**Re: PART 573 NOTICE RE BOOST CONNECTOR**

Safety Defect and Noncompliance Report Guide for Vehicles  
**PART 573 Defect and Noncompliance Report**

# Service Bulletin No. 274

<b>MODEL</b> D Series Coaches	<b>TYPE</b> Field Change Program	<b>SECTION/GROUP</b> 7-Electrical	<b>DATE</b>
<b>SUBJECT</b> BOOST CONNECTOR			
<b>CONDITIONS</b>

**Figure 1. Existing boost connector.**

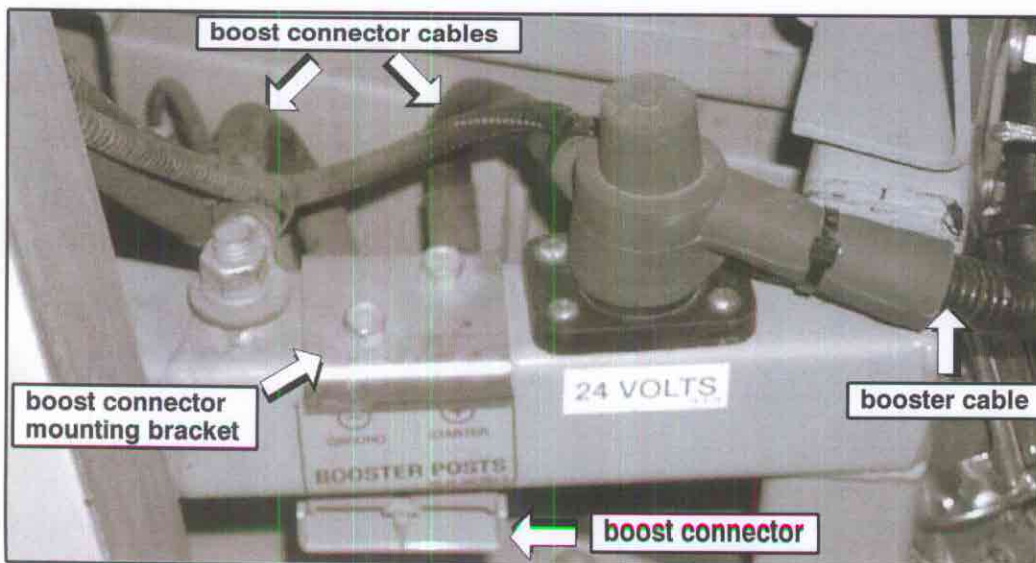
Motor Coach Industries, Inc. ("MCI") has determined that a defect which relates to motor vehicle safety may exist in certain MCI D series coaches that contain a boost connector. MCI has become aware that the boost connector's plastic housing may crack, which can allow the positive and negative leads to come in contact. In rare conditions, this may cause an overheat with arcing, and could result in a thermal event.

2. Open the rear, side service compartment door and locate the boost connector ( Figure 1 ).
3. Clearly identify the existing coach harnesses that are routed to the 24 Volt and Ground booster posts.
4. Remove and retain the nuts, washers, boost connector cables and booster cable from the booster posts.

5. Remove the two capscrews that secure the mounting bracket to the frame. Discard the mounting bracket and the existing boost connector.

Figure 2.

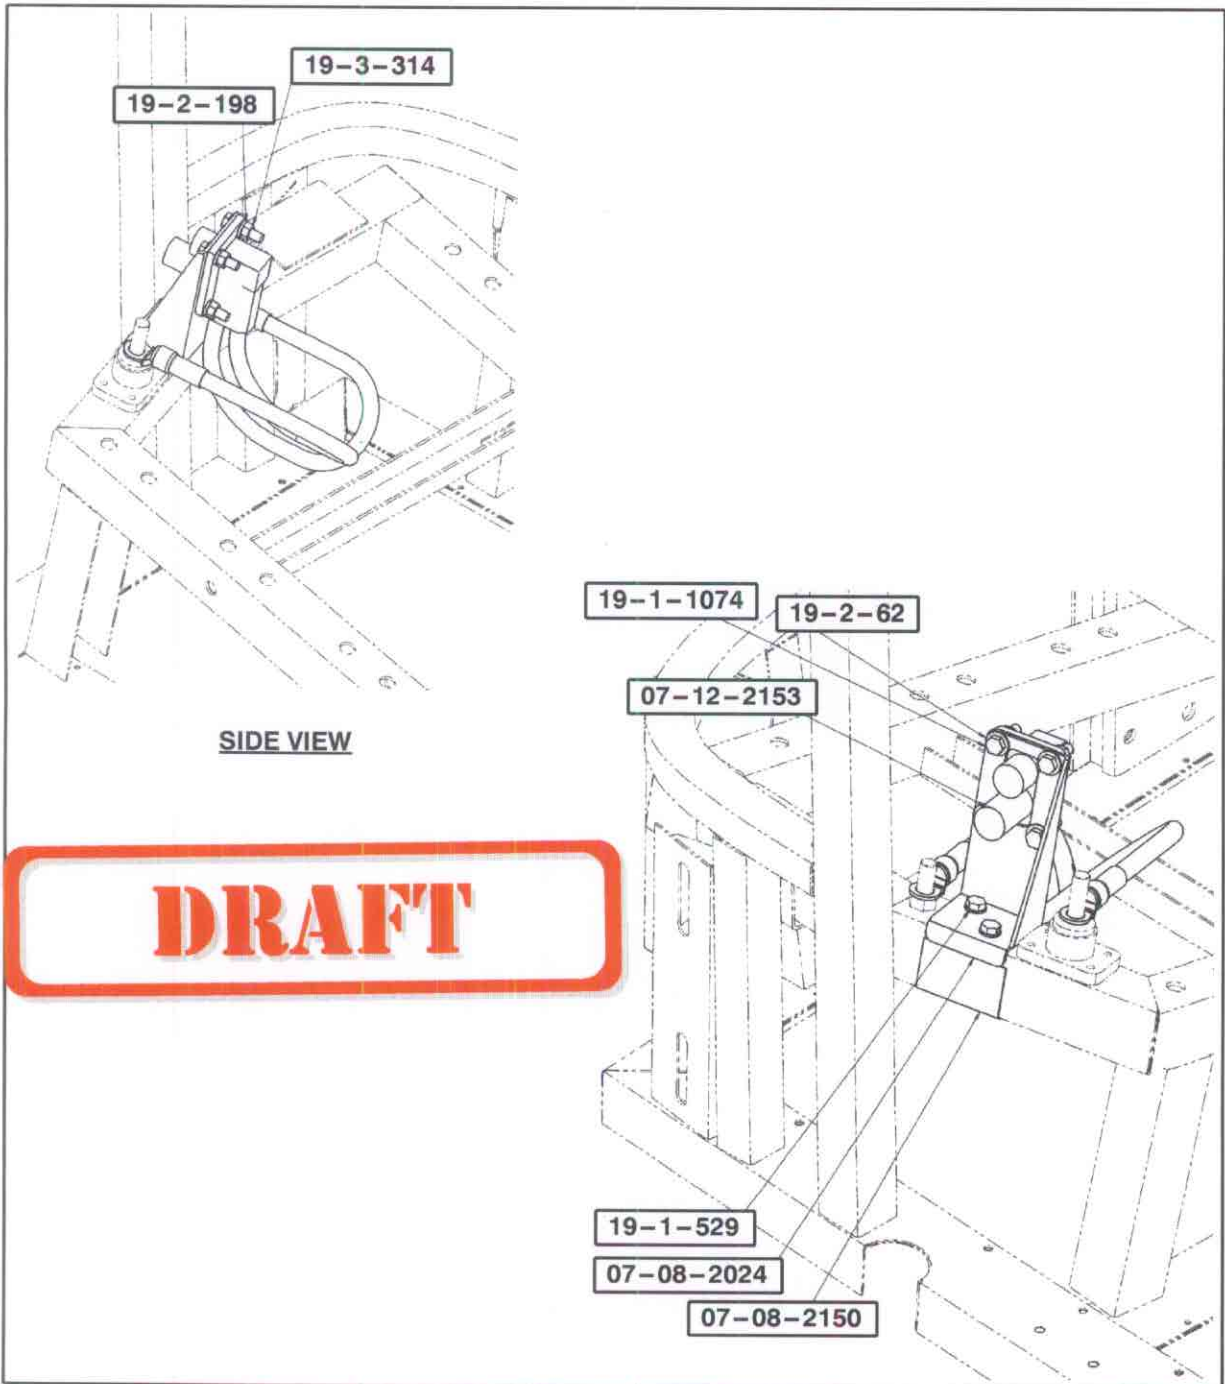
6. Position the mounting bracket ( p/n 07-08-2024 ) on the frame to ensure that the holes align with existing holes in the frame. If necessary, center the mounting bracket and drill two holes with a 3/16 inch drill bit using the bracket as a template.
7. Secure the connector assy ( p/n 07-12-2153 ) to the mounting bracket ( p/n 07-08-2024 ) using the hardware provided in the Parts list ( p/n 19-1-1074, 19-2-198, 19-2-62 and 19-3-314 ) ( Figures 2 and 3 ).

Figure 3.

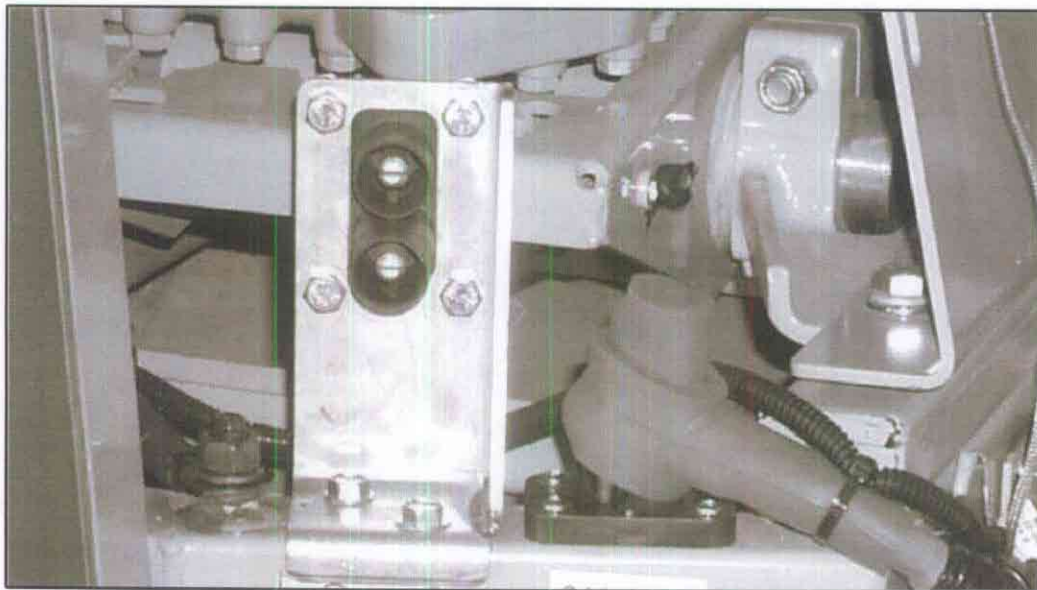
8. Install the booster connector assembly ( mounting bracket ) to the frame and secure the protective cap ( p/n 07-08-2149 ) using two screws ( p/n 19-1-529 ) ( Figures 3 and 4 ).

9. Using a clean cloth and an isopropyl alcohol and water mixture, clean the decal application area shown in Figure 4. Apply the booster posts decal ( p/n 07-08-2150 ).
